# Groundwater Transfer Review Summary Form

Transfer/PA # T- 14818

Application: T-14818

Applicant is requesting to transfer 28 acres from the authorized POA 6.18 miles NW to the proposed POA. The authorized and proposed POAs are listed below.

**Figure 1: Map**

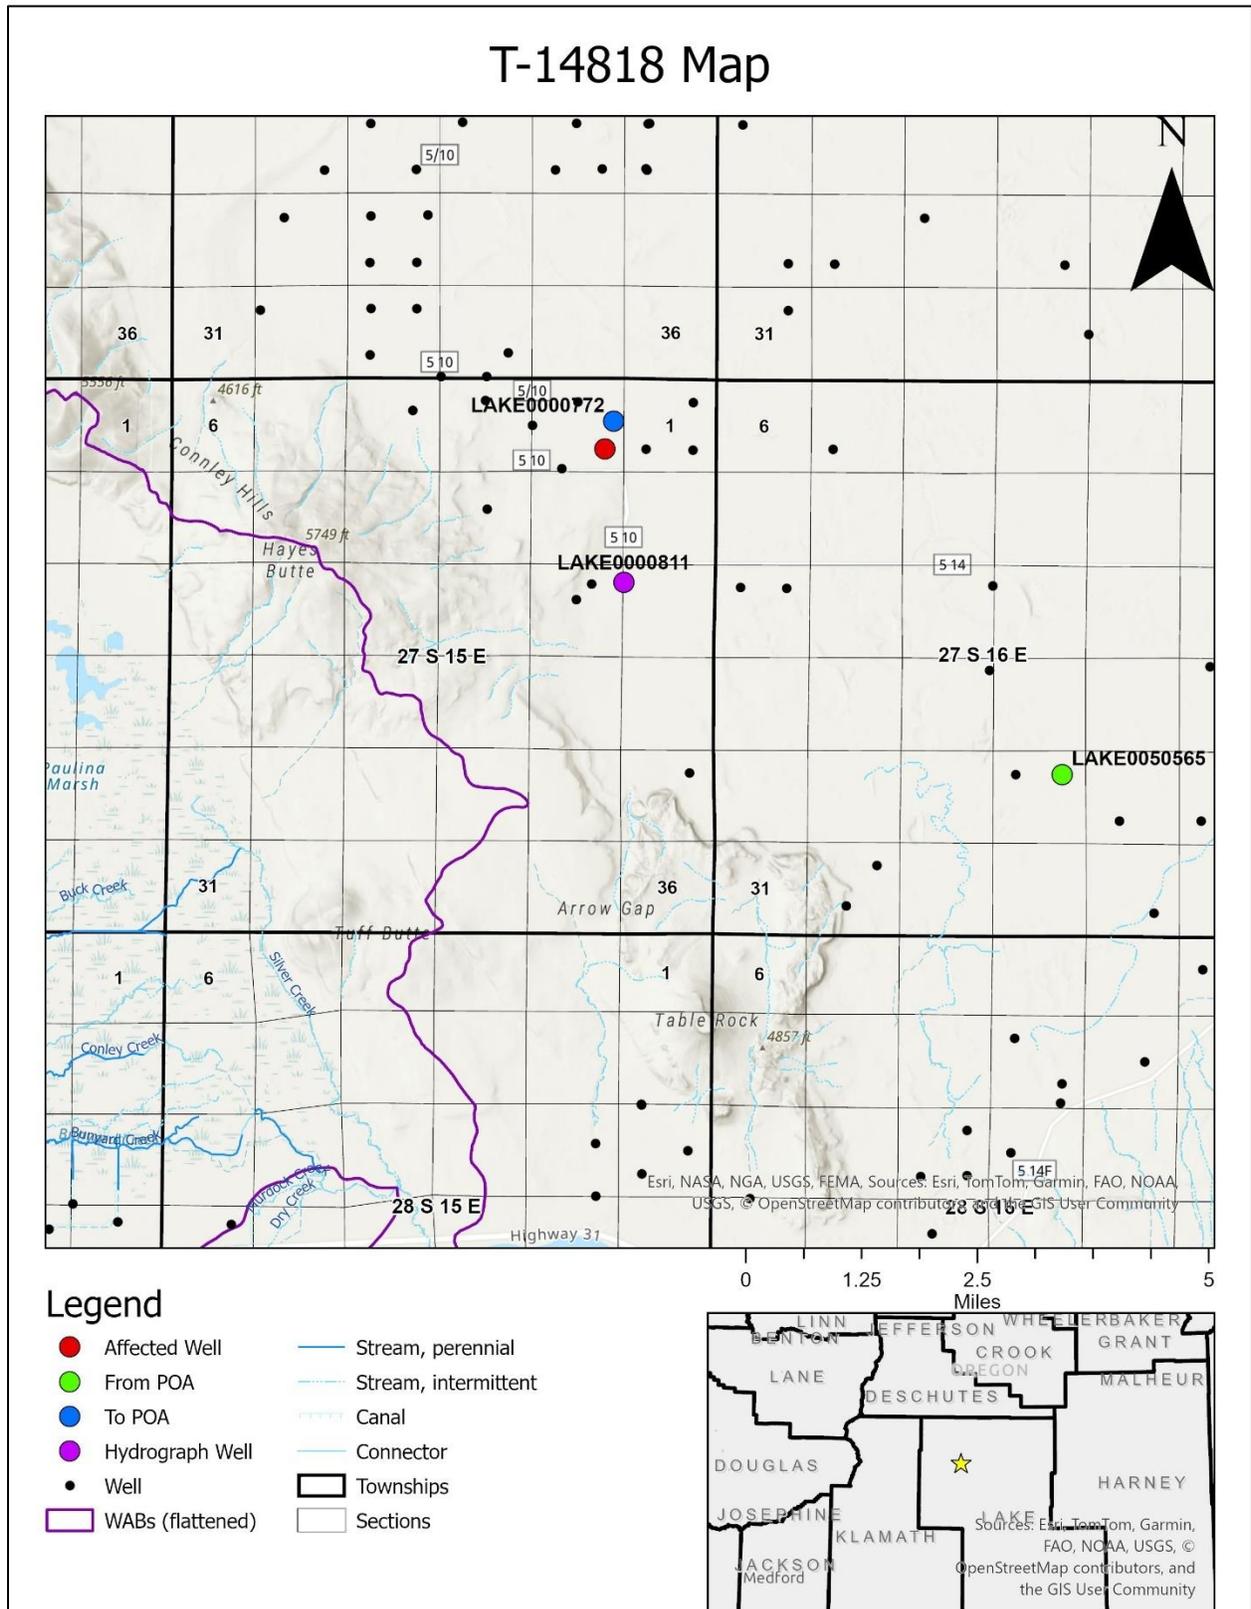
- **Authorized POA: LAKE 50565** (Section 27, Township 27 South, Range 16 East NENE)
- **Proposed POA: LAKE 772** (Section 2, Township 27 South Range 15 East NENE)

**Figures 2 & 3: Drawdown Estimates**

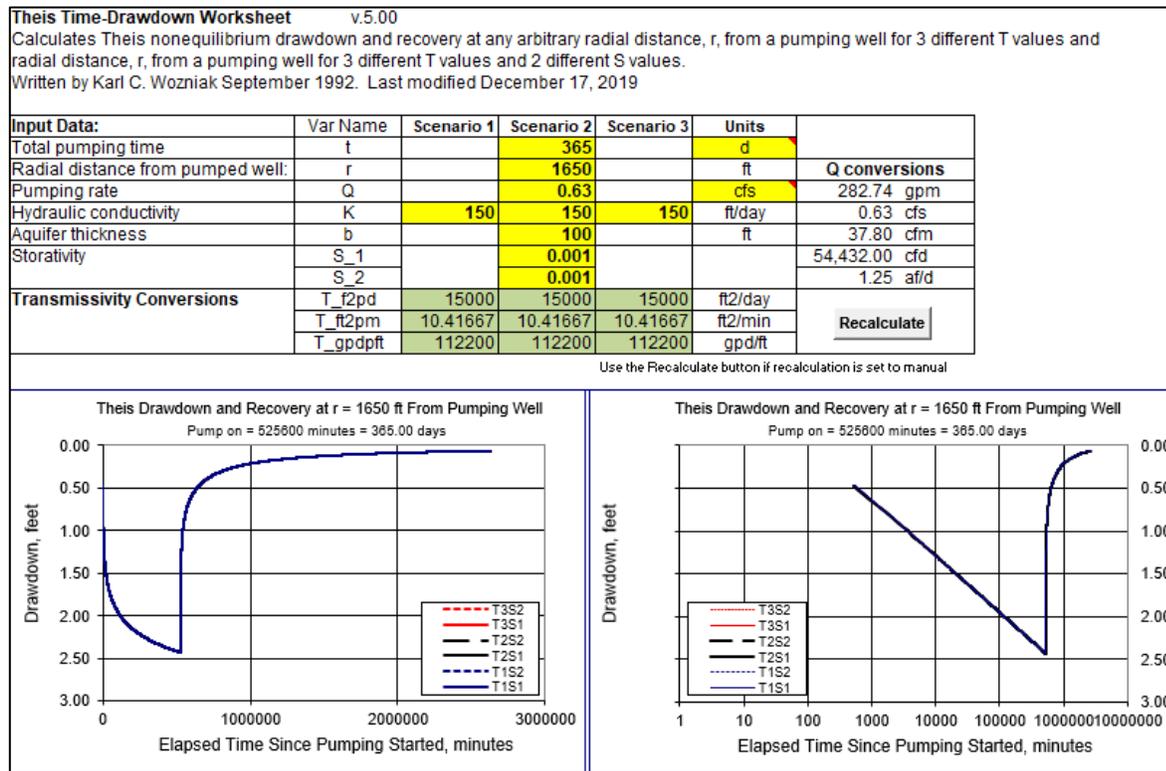
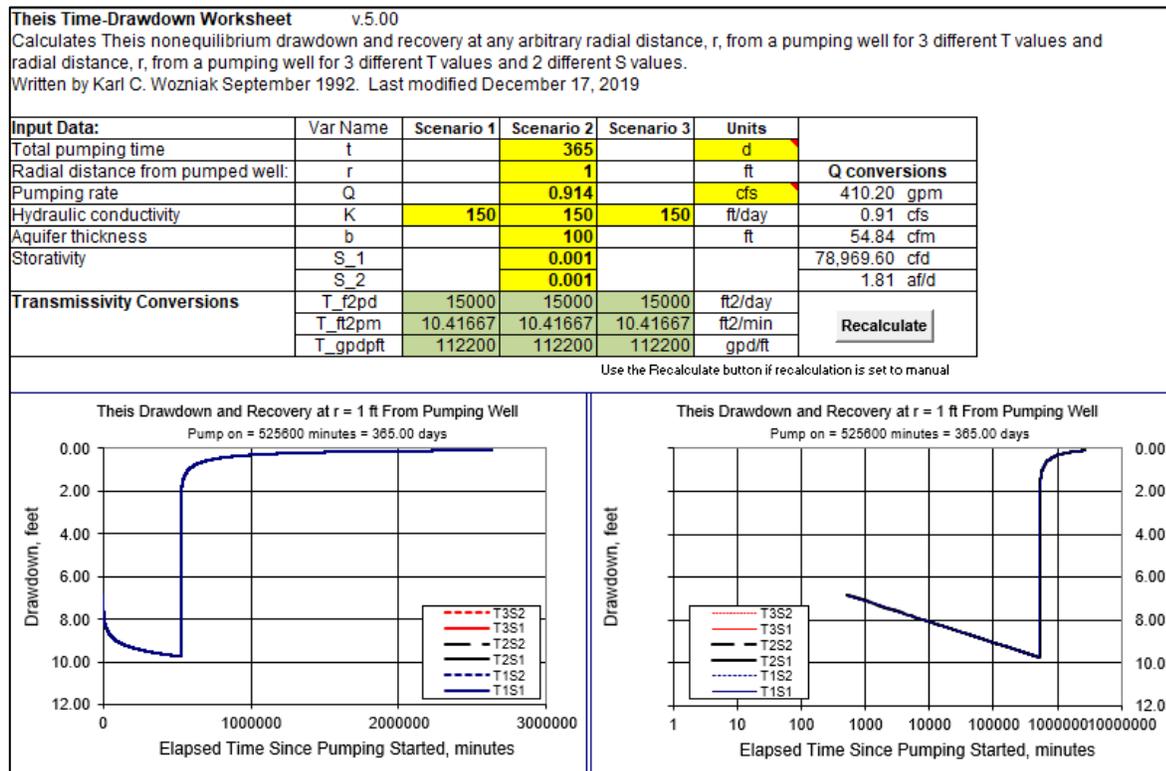
5. a) Will this proposed change, at its maximum allowed rate of use, likely result in an increase in interference with **another ground water right**?  
 Yes  No Comments: The proposed POA is moving closer to LAKE 768. LAKE 768 is 1,650 ft from the proposed POA and 32,000 ft from the authorized POA. The reduced distance to LAKE 768 will likely result in an increase in interference with nearby wells such as LAKE 768.

- b) If yes, would this proposed change, at its maximum allowed rate of use, likely result in another groundwater right not receiving the water to which it is legally entitled?  
 Yes  No If yes, explain: A Theis drawdown analysis was performed for this proposed change in POA using an intermediate storage coefficient of 0.001, transmissivity estimate of 15,000 ft<sup>2</sup>/day from McFarland and Ryals (1991), and a maximum pumping rate of 0.63 CFS for a duration of 365 days. Considering pumping from both the proposed POA and the affected well, the estimated increase in drawdown from the proposed POA is 1.7 ft for a max drawdown of 12.16 ft. This increase in drawdown would not meet the standard of “substantial or undue interference”. The Theis drawdown analysis is included as Figures 2 & 3.
